**ADDENDUM NO. 2 TO DRAFT REMEDIAL ACTION WORK PLAN  
OPERABLE UNIT 3, POHATCONG VALLEY GROUNDWATER  
CONTAMINATION SUPERFUND SITE, WARREN COUNTY, NEW JERSEY**

November 14, 2019

Attachment 1 – Responses to USEPA Request for Clarifications Received by E-Mail Dated 11/4/2019

Attachment 2 - Addendum No. 2 to Draft Remedial Action Work Plan

L:\Loop Project Files\CAD\1690014983\_ISTR System Design Mods-Updates to RAWP\_003\D-5\_Post-ISTR Operation 1A and Sub-Slab VS Locations.dwg

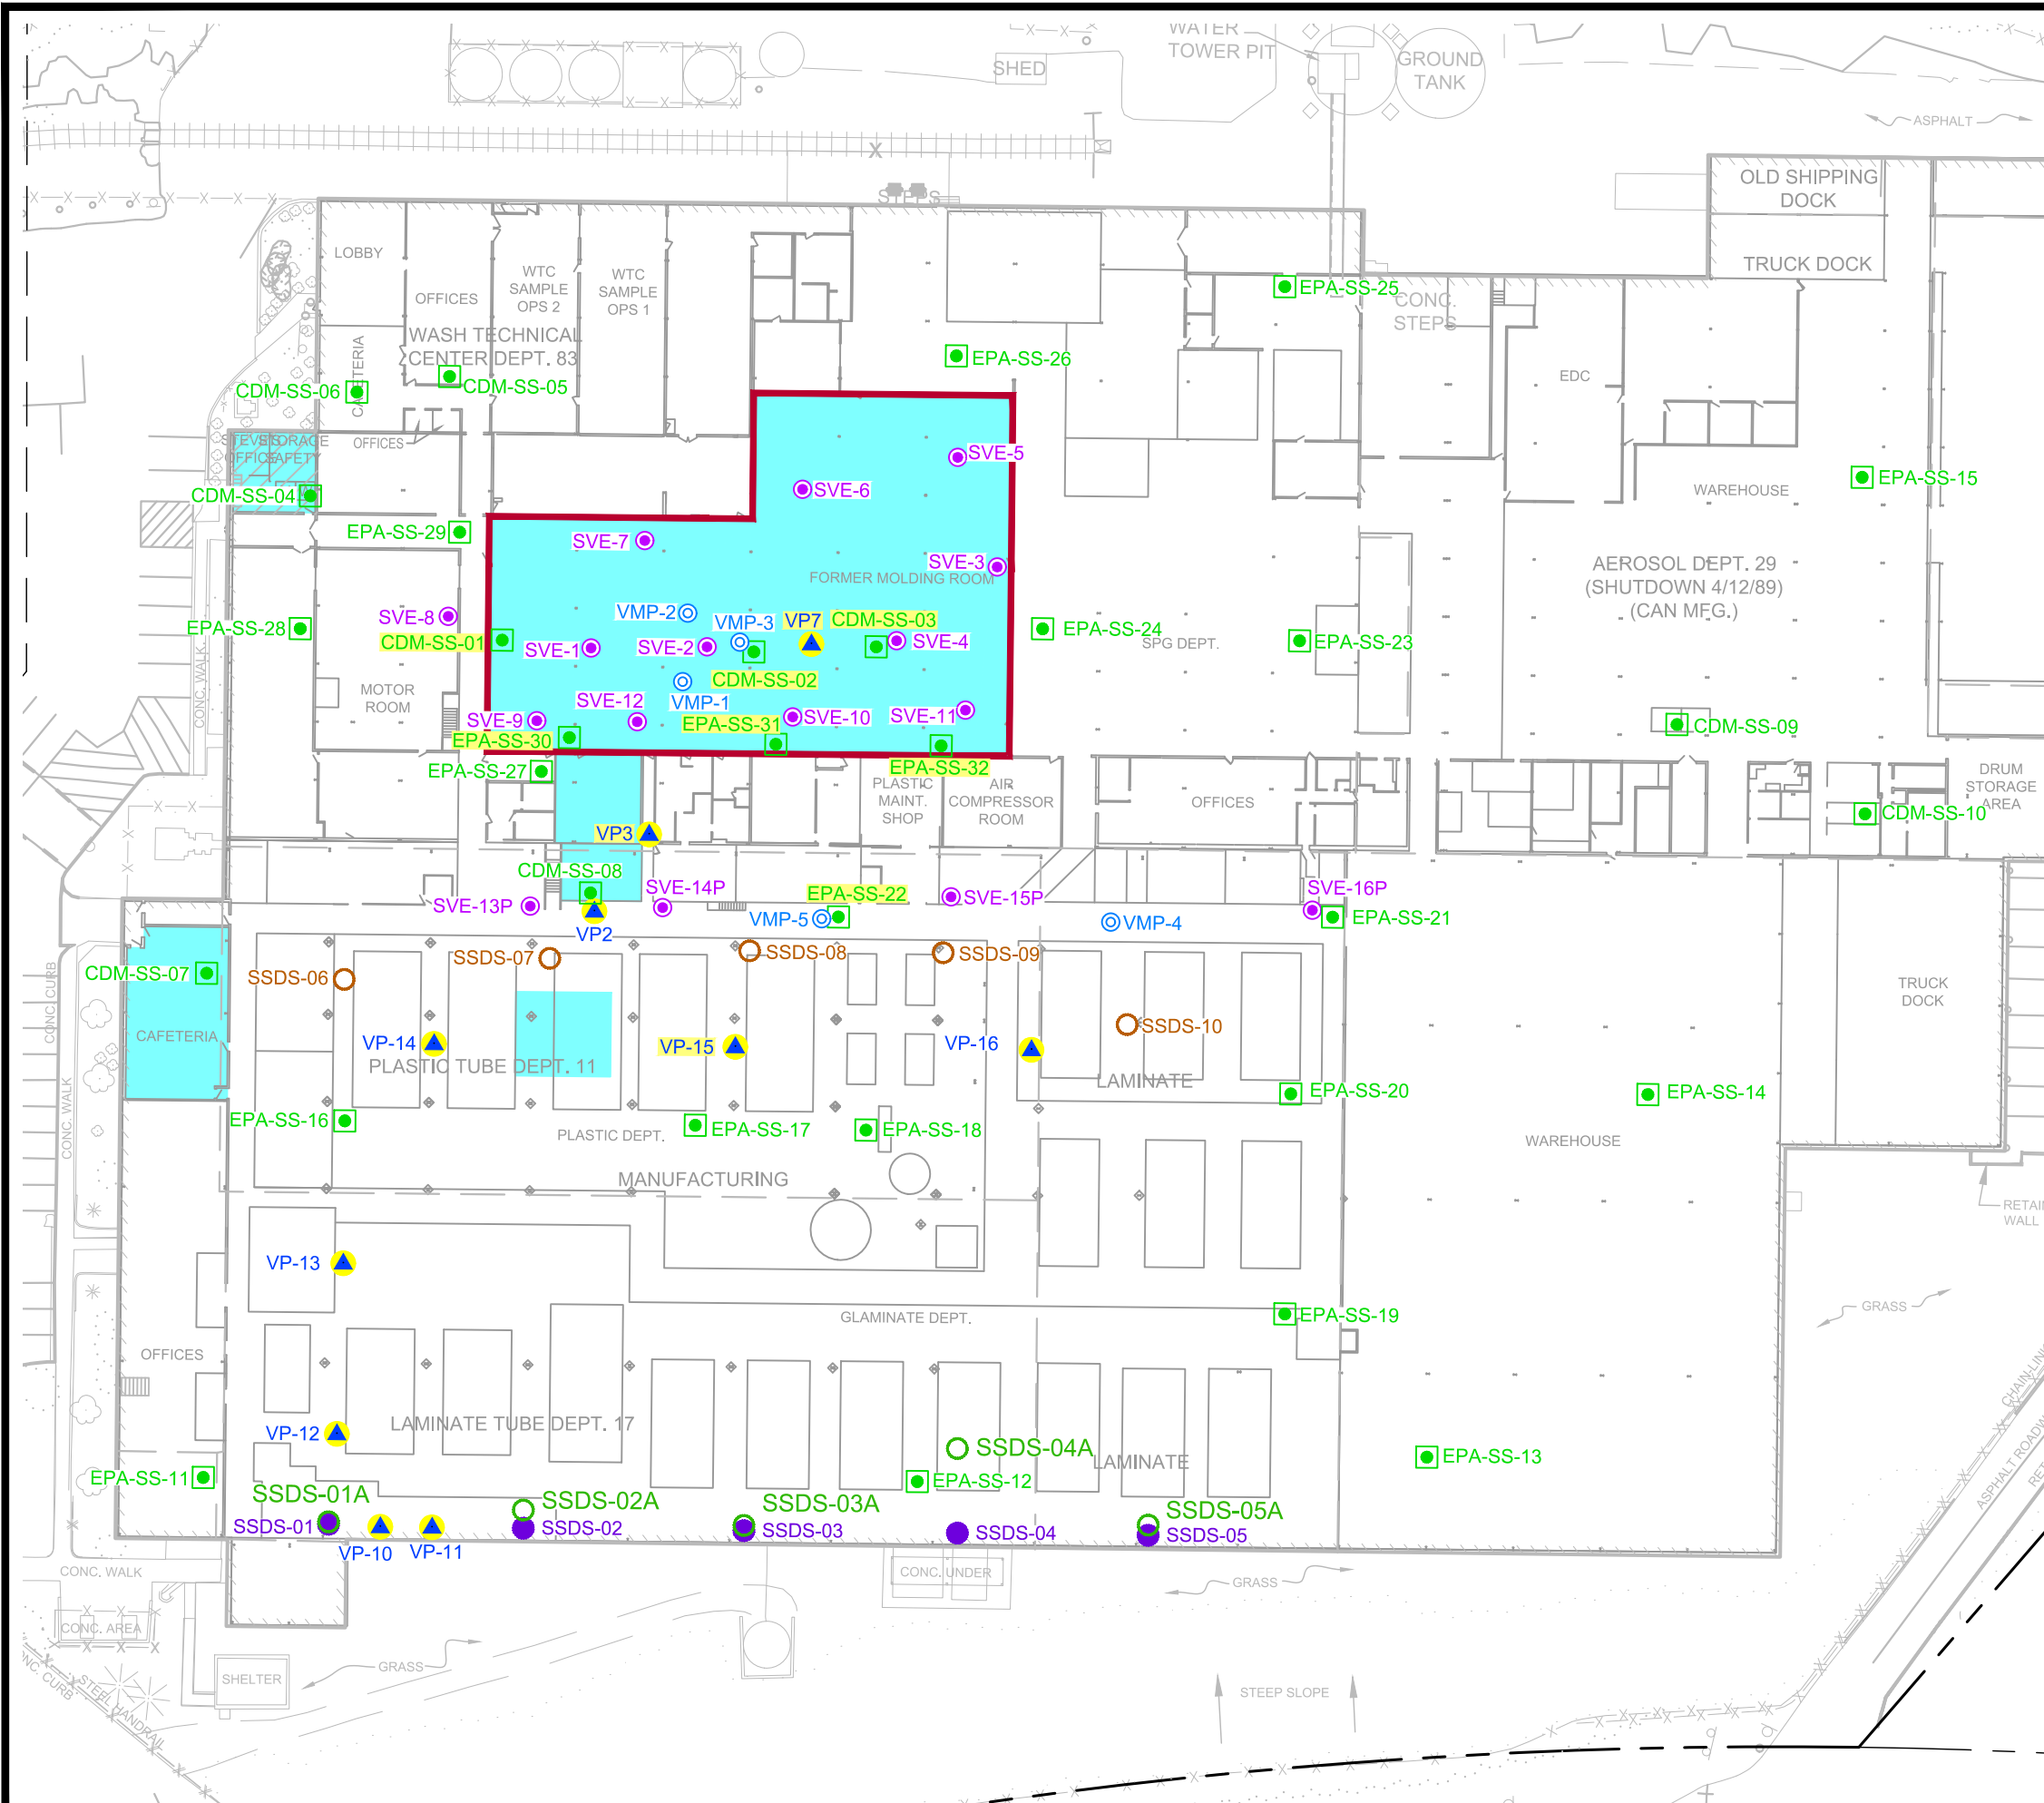
The locations of these indoor areas and sub-slab vapor monitoring points are shown on Figure D-45. The samples will be collected and analyzed for VOC using USEPA Method TO-15 in accordance with the QAPP. Indoor air and sub-slab vapor samples will be compared to site specific regulatory criteria as described in the ROD.
